THIRD PRINTING (Updated April 15, 2020)

2015 International Building Code Errata (Portions of text and tables not shown are unaffected by the errata)

Figure 2603.8 TERMITE INFESTATION PROBABILITY MAP

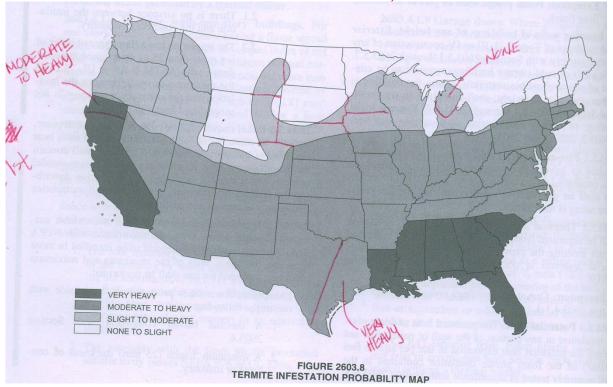
Add state lines in the middle of the map Change the color indications in California, Michigan and Texas as indicated (same as 2015 IRC Figure R3012.6)
